C Organizational Control of Emergencies

C.1 Normal Station Operating Organization

Figure C-1 Onshift Emergency Response Organization

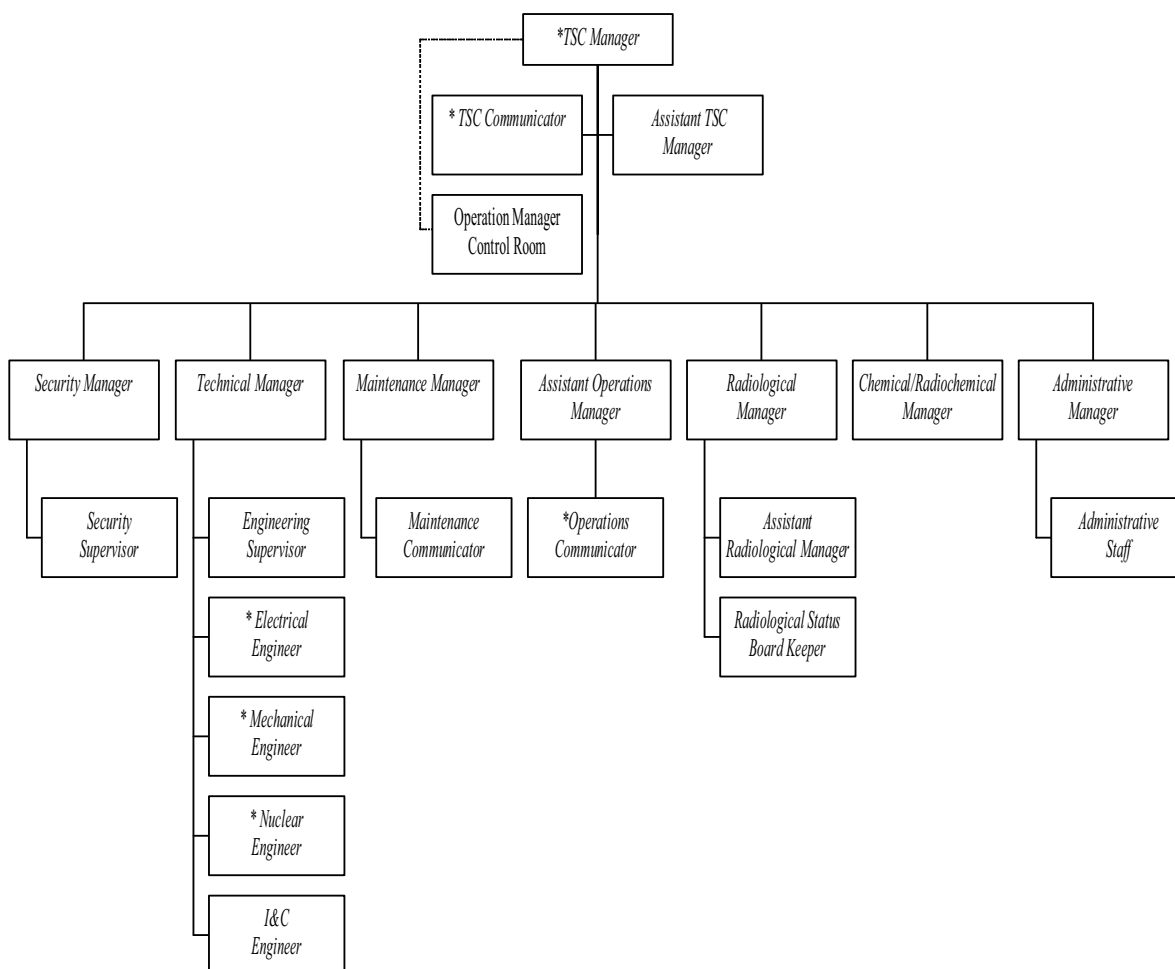
~~(1) Shift Supervisor; (2) Plant Protection; (3) Reactor Operator, currently or previously licensed by NRC, or SRO Management Certified Personnel; (4) Duty Maintenance Supervisor; (5) Plant Operator; (6) Security Force Supervisor; (7) Senior Radiation Technician.~~

~~(2)~~

~~() - Identifies onshift personnel position titles~~

(1) Shift Supervisor;

(2) Plant Protection

(3) Reactor Operator, currently or previously licensed by NRC, or SRO Management Certified Personnel

(4) Duty Maintenance Supervisor

(5) Plant Operator

(6) Security Force Supervisor

(7) Senior Radiation Protection Technician.
